Planning Application Ref: **AW/347/20/T**

Location: **4 Lucerne Court, Aldwick, PO21 4XL**

Description of works: **1no. ash tree (T1) - Crown lift to 2.5m-3m and reduce crown to height 13m and lateral spreads 8-9m**

Figure 2 Positions of final cuts

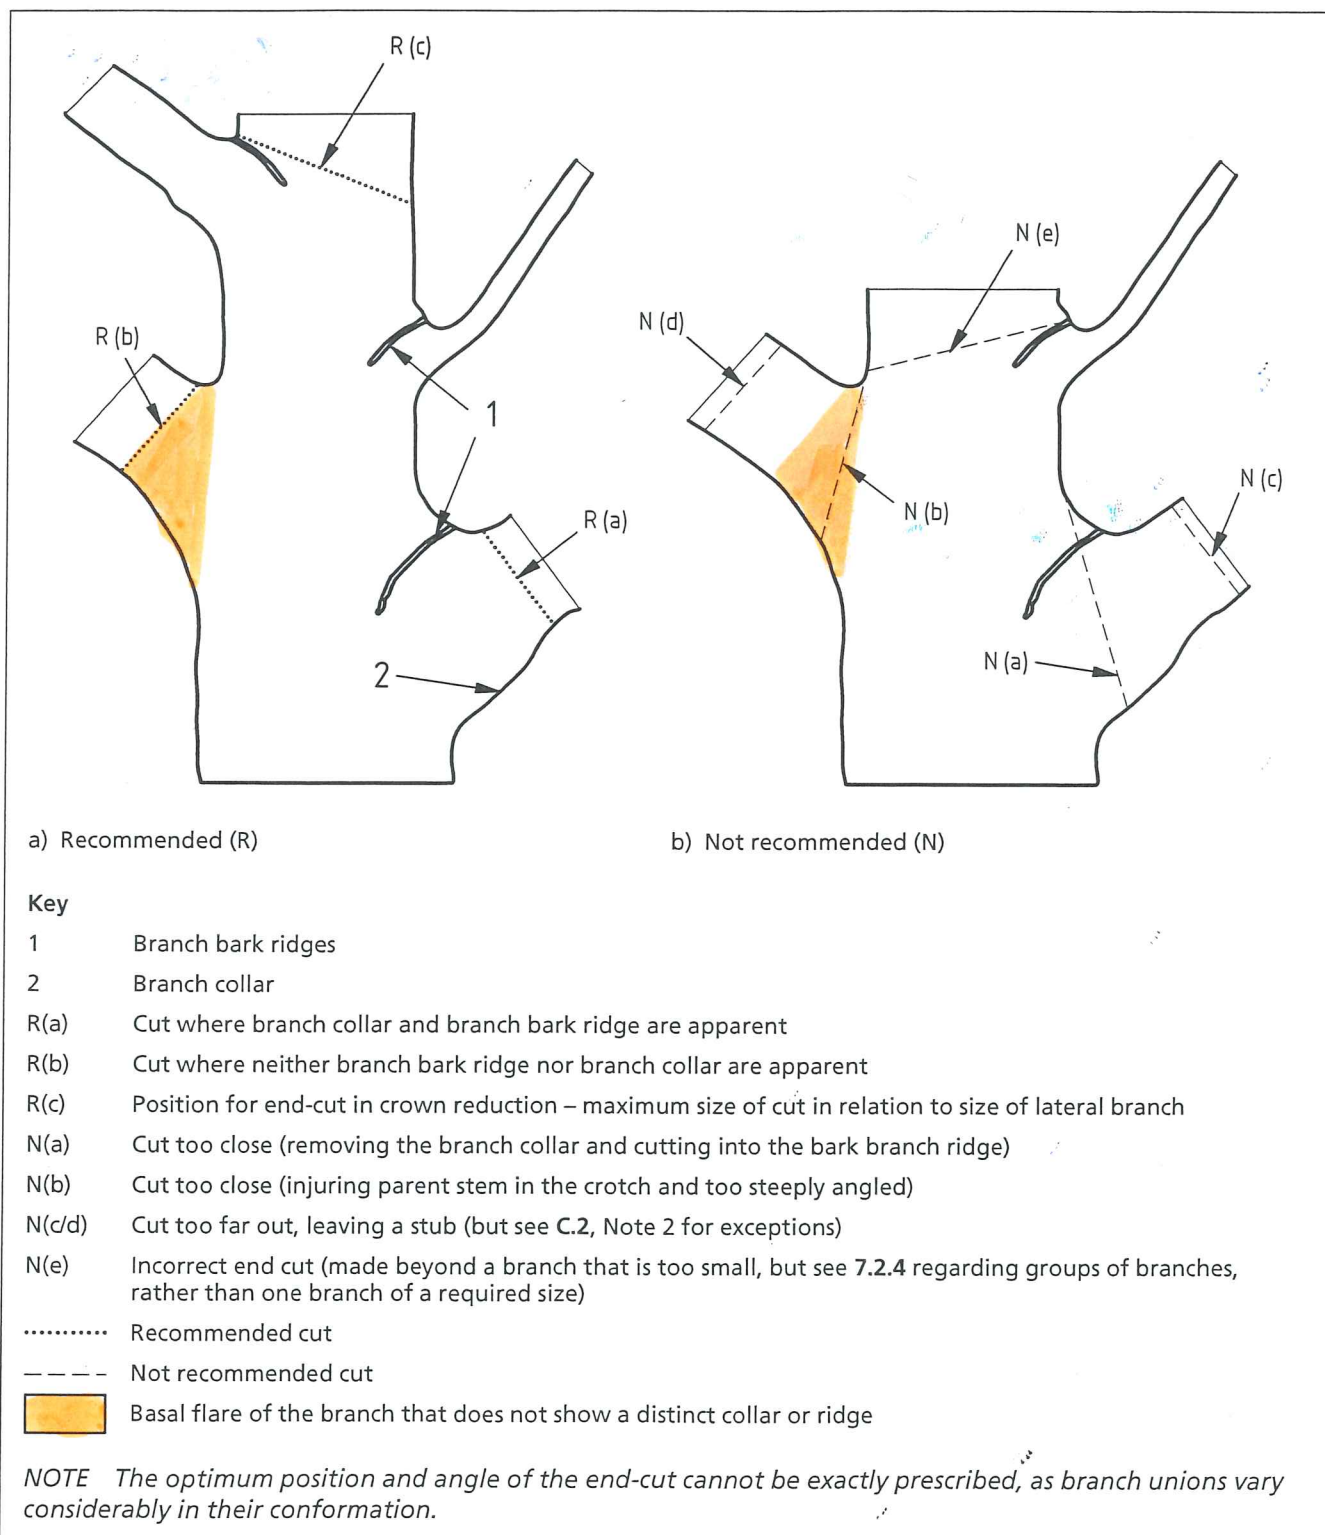
- Part a) Where whole branches are to be removed and final cuts made close to the trunk or branch union they are to be made as shown in Figure 2 of BS3998:2010
- Part b) Where branches are to be shortened back the final cuts are to be made at the correct angle shown in BS3998:2010 and adjacent to a live bud or lateral.
